**METROPOLITAN GOVERNMENT OF NASHVILLE AND DAVIDSON COUNTY**

**STAFF RECOMMENDATION**  
**4407 Park Avenue**  
**August 15, 2018**

**Application:** New Construction—Addition  
**District:** Park and Elkins Neighborhood Conservation Zoning Overlay  
**Council District:** 24  
**Map and Parcel Number:** 09116003900  
**Applicant:** Axis Creative, LLC; Will Jenner, Designer  
**Project Lead:** Sean Alexander, sean.alexander@nashville.gov

**Description of Project:** The applicant is proposing to enlarge the house with a new rear addition.

SITE PLAN

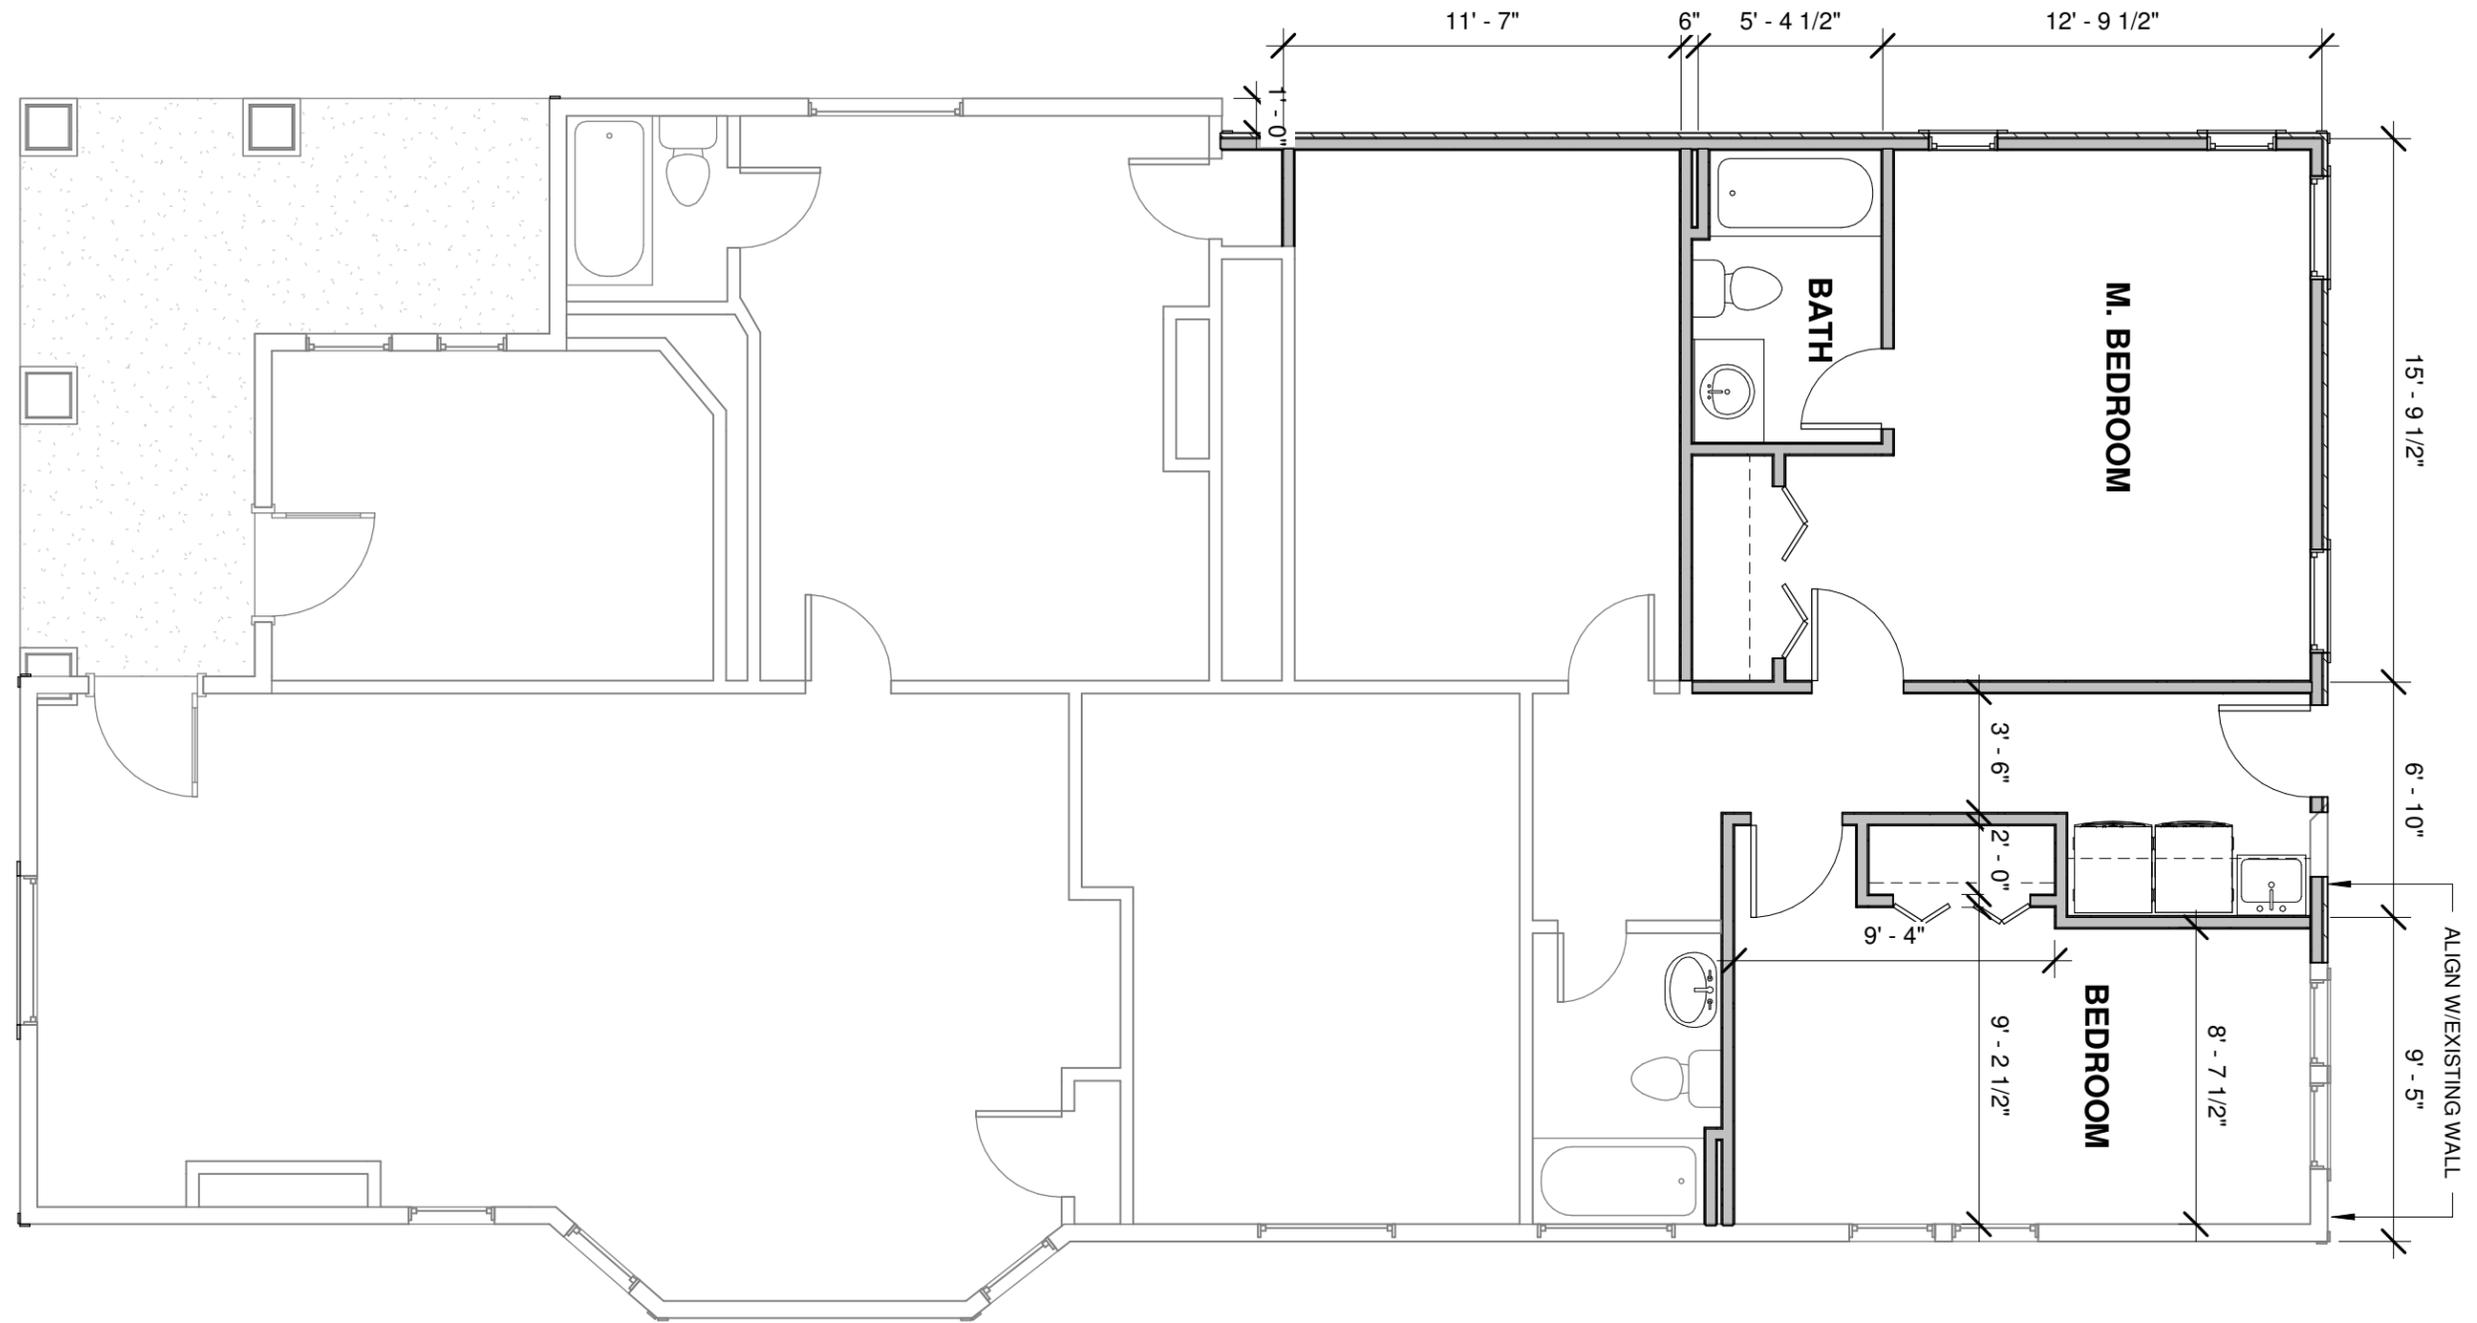
Location & Removability: The new addition will be located behind the rear of the historic house, stepped in from the left side of the house by one foot (1’) and continuing back to “square off” the rear wall of the earlier addition.

Appurtenances & Utilities: No changes to the site's appurtenances were indicated on the drawings. The location of the HVAC and other utilities was not noted. If they are relocated, Staff asks that the HVAC be located on the rear façade, or on a side façade beyond the midpoint of the house. With that condition, Staff finds that the project meets section II.B.1.h of the design guidelines.

LEFT ELEVATION

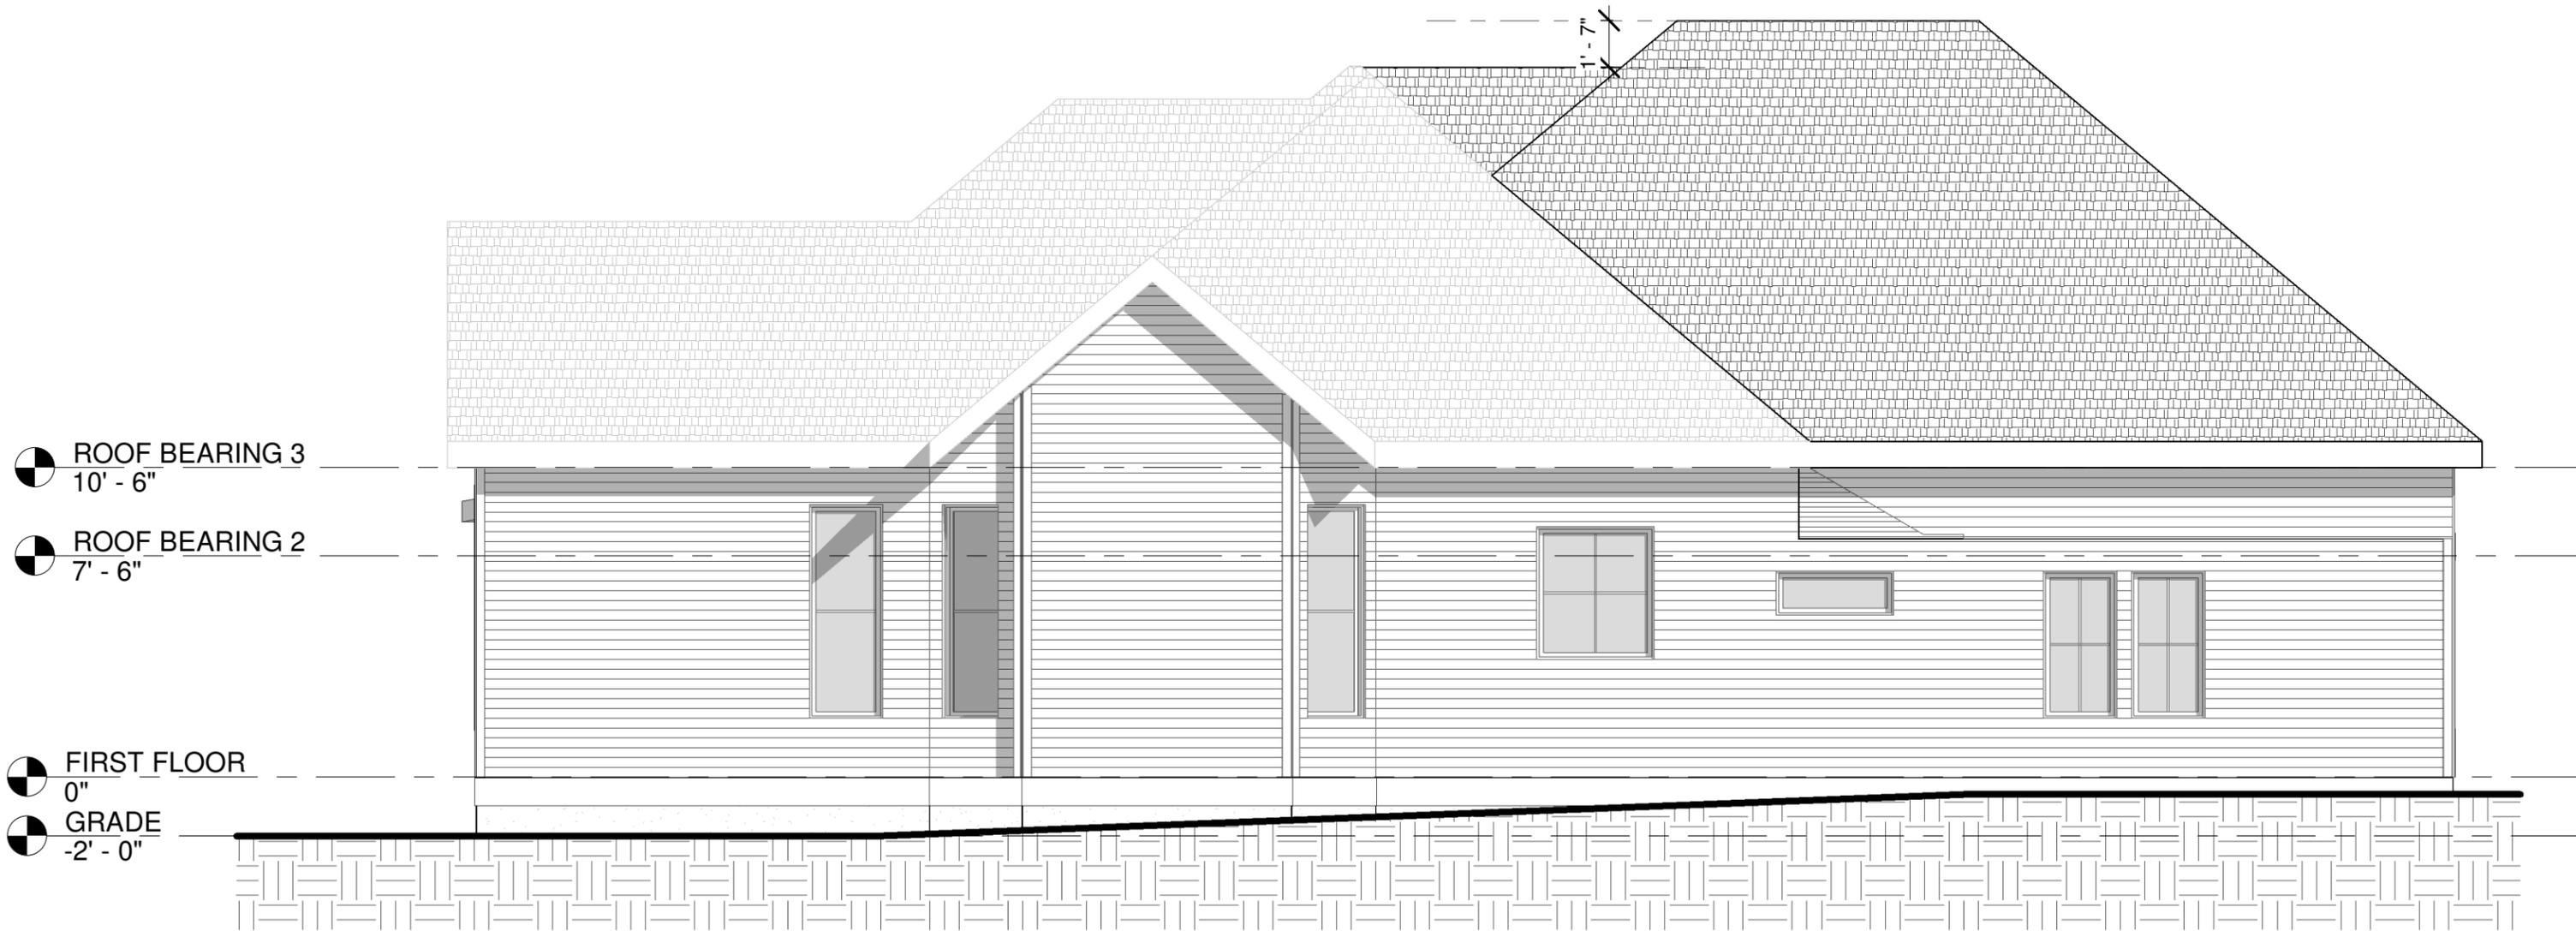
1. A window opening shall be added to the left wall of the addition; and
2. The HVAC units and utility connections shall be on the rear or a non-street facing façade.

Proportion and Rhythm of Openings: No changes to the window and door openings on the existing house are proposed. The addition would have two windows on the left side and four windows and a door on the rear. All of the openings are approximately twice as tall as they are wide, as is typical of windows on historic houses. The proposal shows that there would be an eighteen foot (18') section of wall on the left side of the addition without any opening. Historic houses in the area typically have a regular rhythm of wallspace with an opening every ten to twelve feet (10'-12'). With the condition that a window is added on the left side of the addition, Staff finds that the project's proportion and rhythm of openings will meet section II.B.1.g of the design guidelines.

1. A window opening shall be added to the left wall of the addition; and
2. The HVAC units and utility connections shall be on the rear or a non-streetfacing façade.
